PCB 07-01332 ISSUE 3
ASSY P/No. 08-03944-001

DRN.	D.S	SCALE	COPYRIGHT © CODAN PTY LTD A.C.N. 007 590 605	
	CHKD.	NJA	2:1	DISPLAY BOARD ASSEMBLY	
MATERIAL	APPD.	NJA	DATE	DRAWING/DOC No.	
FINISH	TOLERANCES UNLESS OTHERWISE STATED		14-9-89	A2 08-03944	
2 PLACES DEC 1 PLACE DEC ANGULAR			ISS	SHT	
			1	2	3
			4	5	1

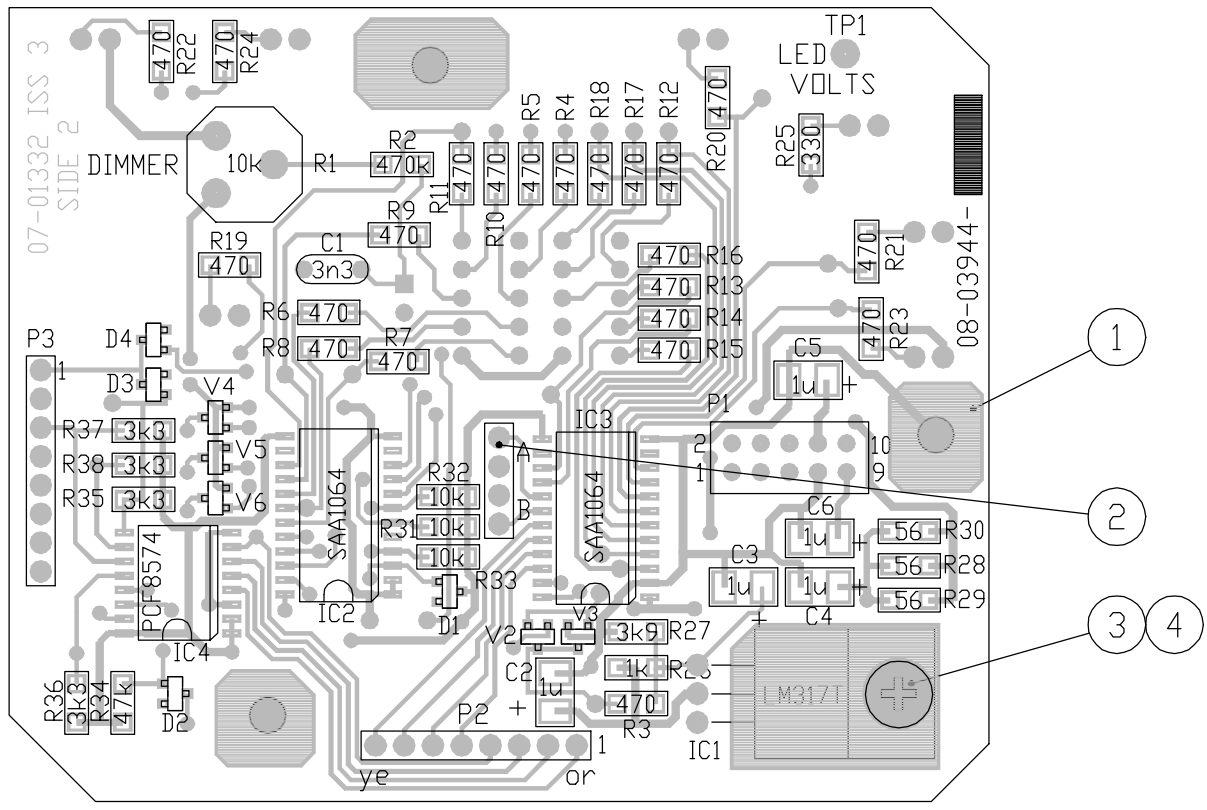
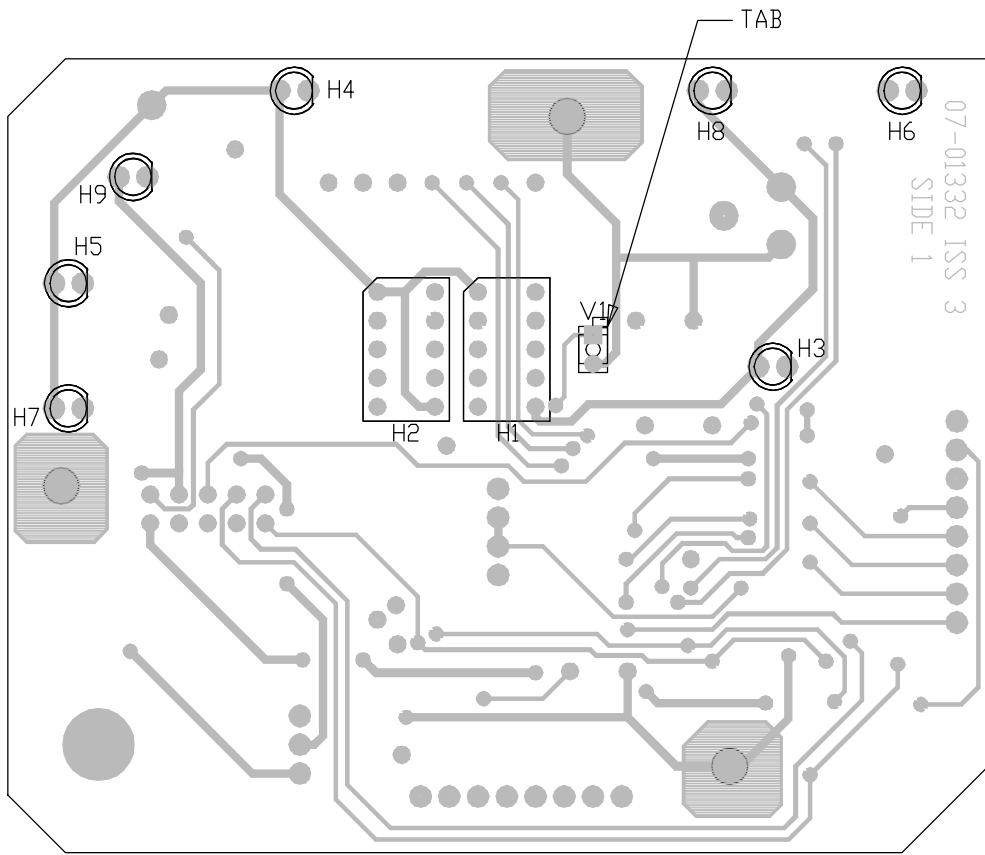
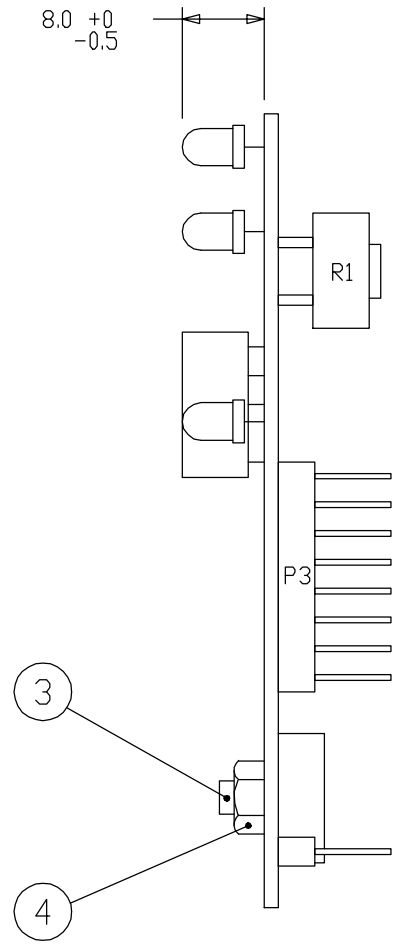
CHANGE REQUEST	
ISSUE B	R34 WAS 4k7
C/R 22128	14-9-89 NJA
ISSUE 2	P3 WAS J1
C/R 22142	27-10-89 NJA
ISSUE 3	H1 & H2
TRANSPOSED.	C/R 22253
20-12-89	NJA
ISSUE 4	P3 CHANGED
C/R 22300	15-3-90
PCB WAS ISS. 1	BOTTOM L/H CNR
WAS 90 deg.	C/R 22200
14-4-90	NJA
ISSUE 5	SMD LAND
PATTERNS	UPDATED.
PCB WAS ISS. 2	C/R 23135
BCL 30/4/93
